HISTORIC DISTRICT REVIEW BOARD

Wednesday, January 14, 2026, 2:00 P.M.

STAFF REPORT: Historic District Review Board (HRB)

1705 DUKE STREET

❖ **Contextual Streetscape with proposed dwelling (as presented at HDRB Meeting on 11/12/25):**

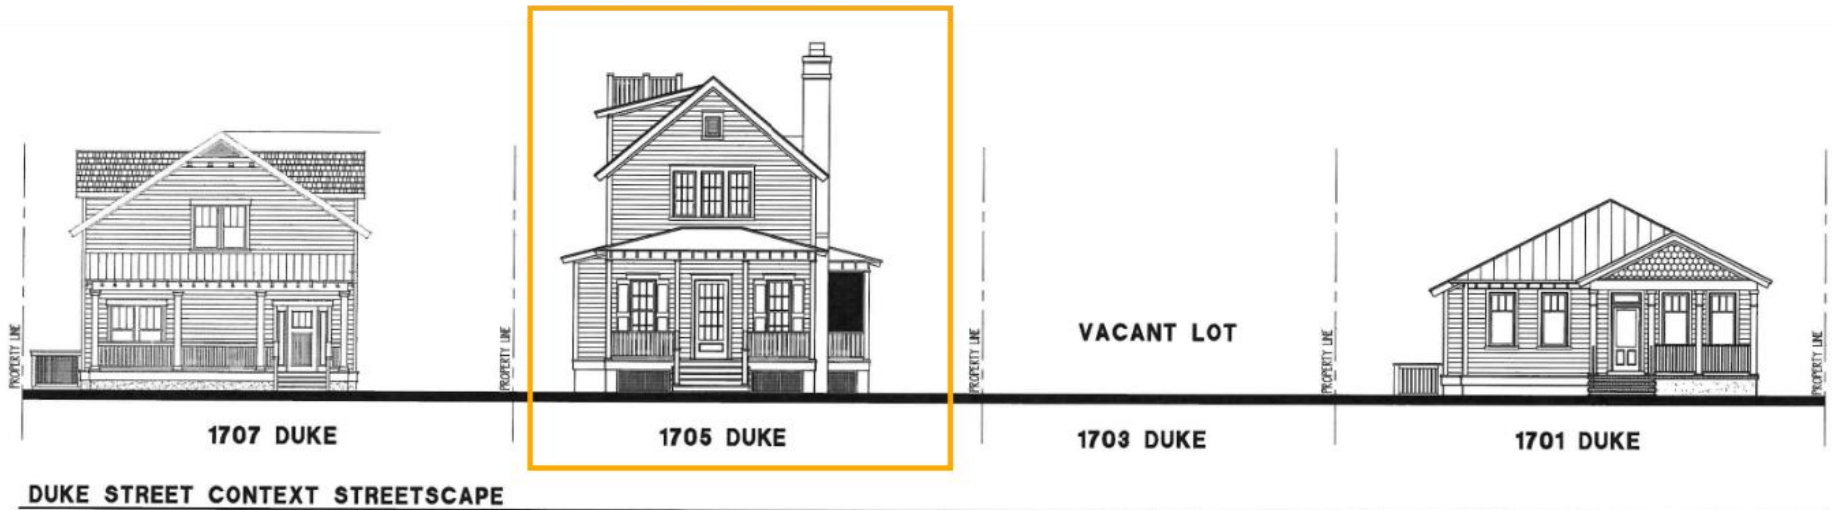
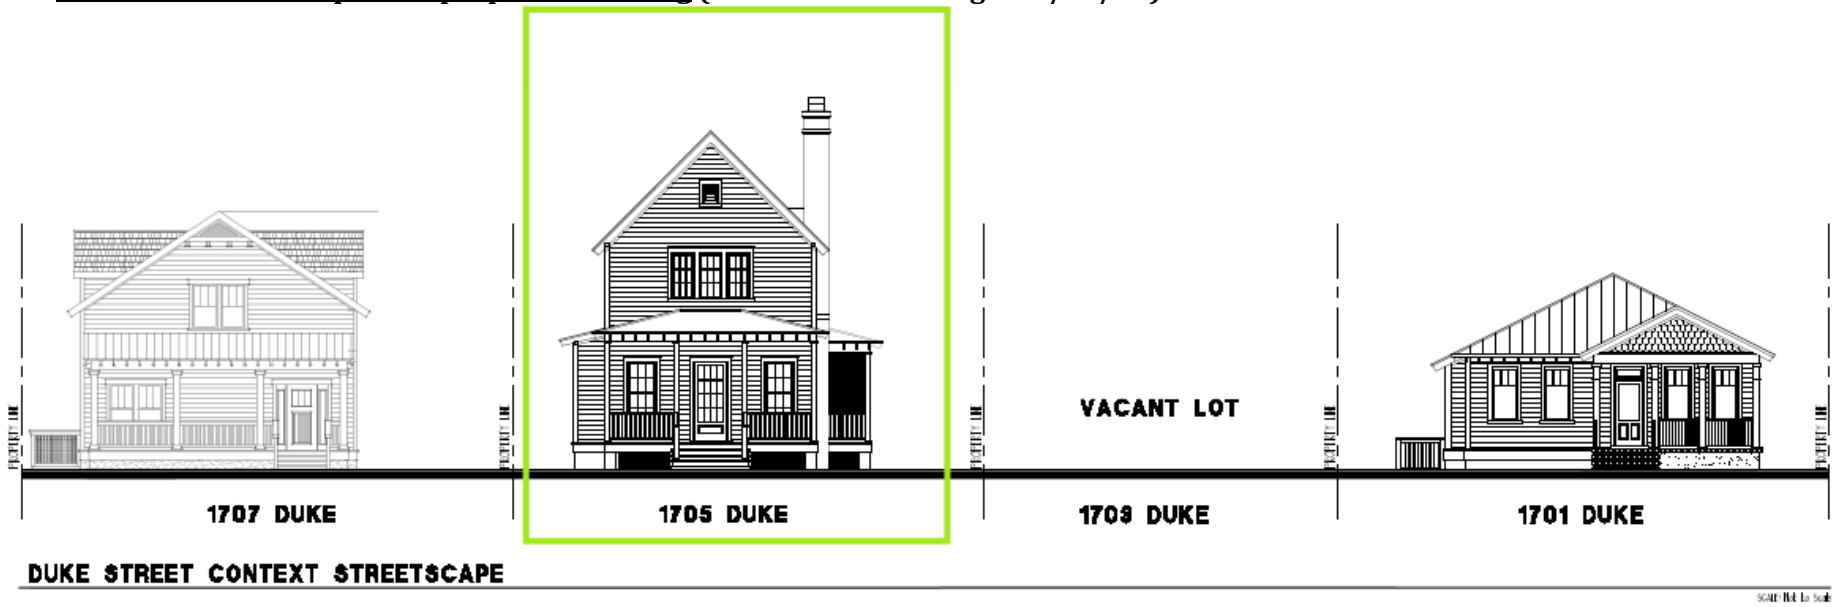
- Staff requests a street section depicting the heights of the adjacent structures. Staff is supportive of a two-story structure on this site but may suggest reducing the slope of the main roof from 12/12 to 11/12 or 10/12.
- Staff is not supportive of the widow's walk that is disguised as a dormer. A side elevation showing this condition was not provided, and staff believes this is an atypical detail for the historic district.
- Staff recommends moving the first-floor window on the right elevation so that it is not placed directly behind a column. This may require slight interior reconfiguration. It may be possible to convert the screen porch to a five bay configuration and eliminate this alignment concern.
- Staff noticed that the front door is 4' wide, which is atypical. Applicant to clarify why a 3' wide door was not used. Staff could be supportive of a 3' wide door with sidelights.

■ **Staff Recommendation #2: Removal of Widow's Walk (West elevation)**

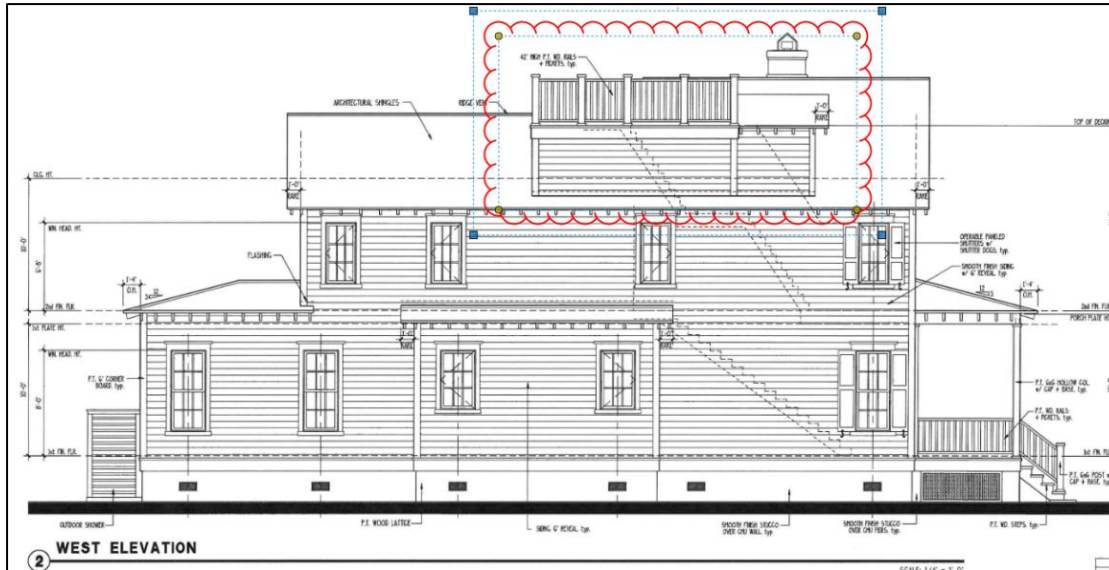
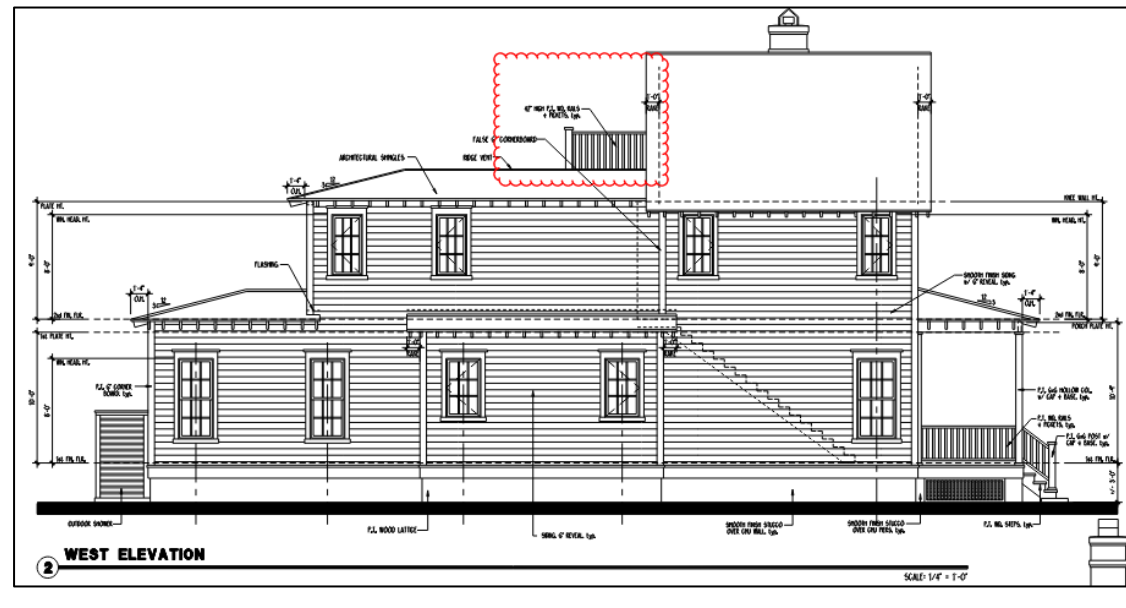
Staff recommendation (1st HDRB Mtg.):

- “Recommendation to remove proposed widow’s walk feature on top of the roof and as a result, restudy western elevation to better match with the eastern elevation.”

2. Recommendation to remove proposed widow’s walk feature on top of the roof and as a result, restudy western elevation to better match with the eastern elevation. **Applicant has removed rooftop “widow’s walk” and replaced it with a second-floor north-facing balcony (at the rear) instead. As such, the balcony is not visible from Duke Street.**

▪ **East elevation:**

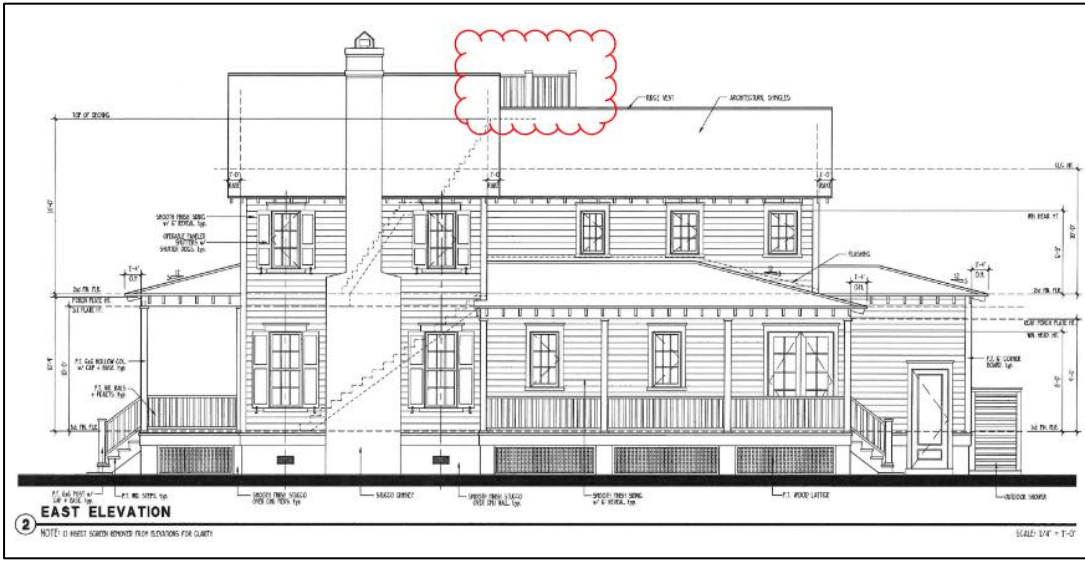
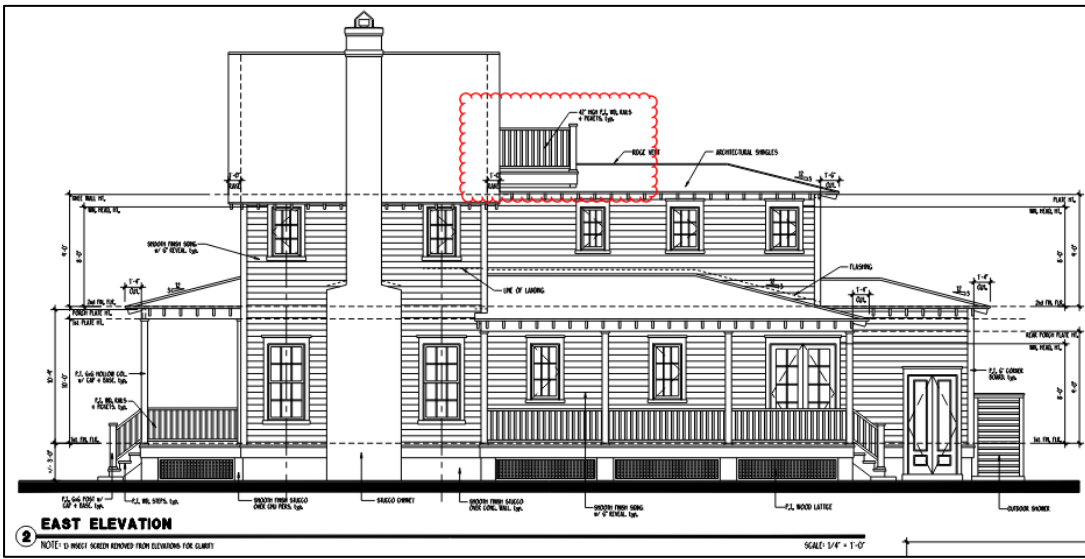
Staff comment:

- Removal of “Widow’s Walk” & replacement with balcony better matches with west elevation

▪ **Staff Recommendation #5 – Fence design:**

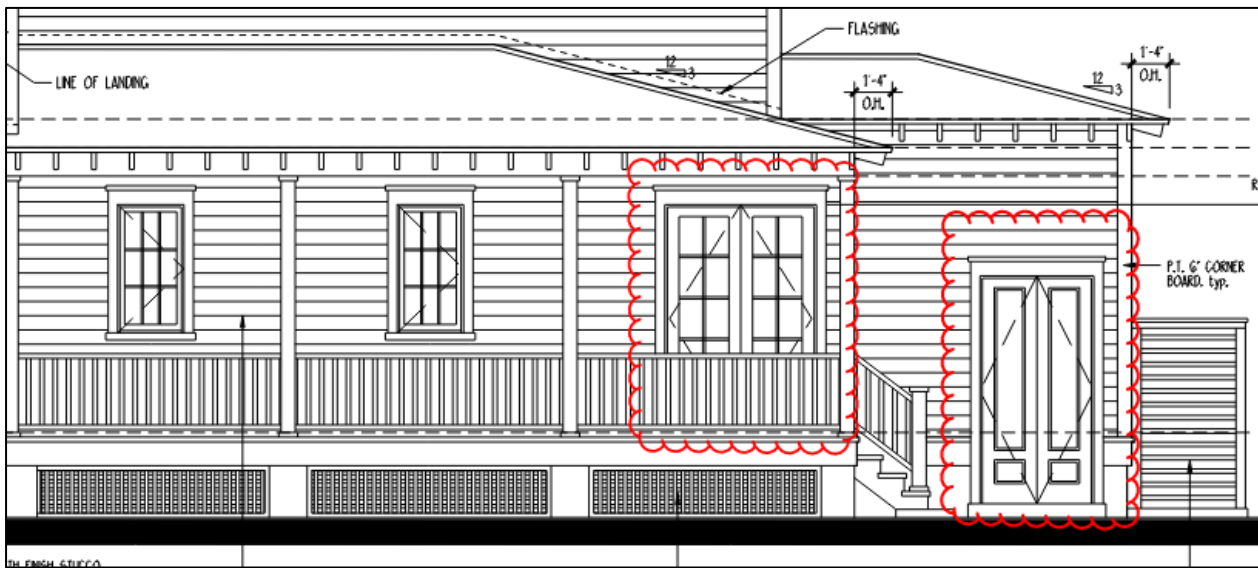
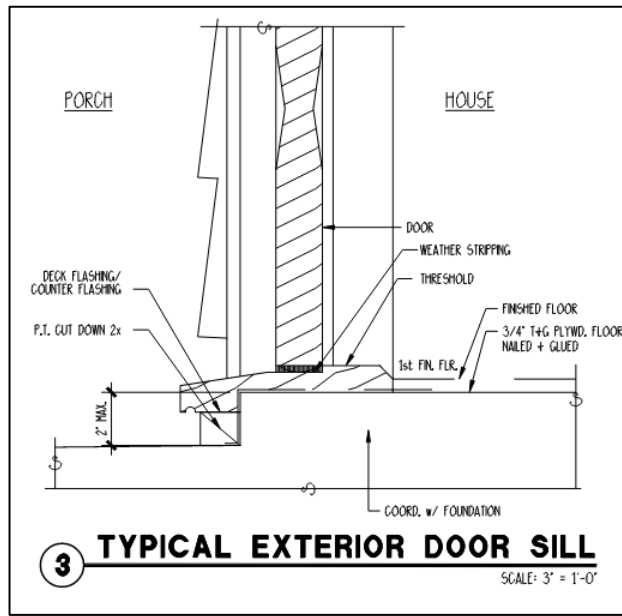
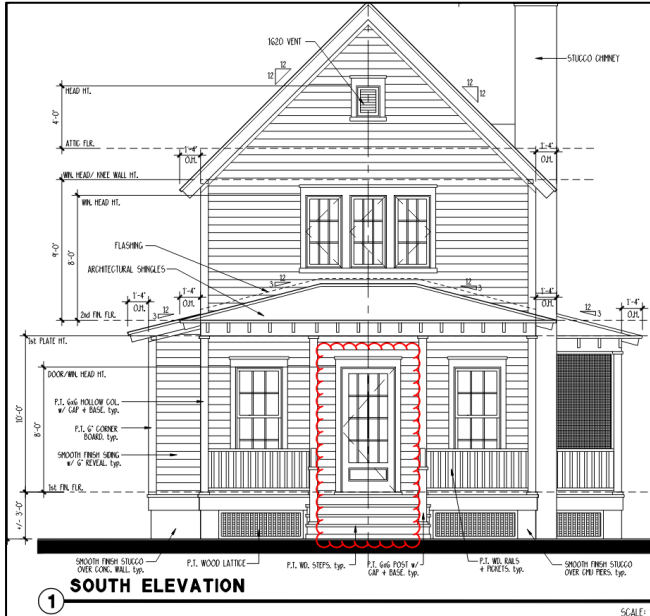
Staff comments:

- Living fence is a permissible fence design for the Historic District in accordance with the Beaufort Preservation Manual
- As per Sec. 5.8.2.C: “All fences shall be 4 feet in height or less along all setbacks. Exceptions may be approved by the Historic District Review Board (HDRB).”

5. Applicant to provide a design for the fence at a future meeting. **Applicant has submitted picture for a classical living fence.**
6. Applicant to label all materials and provide detail drawings, including:
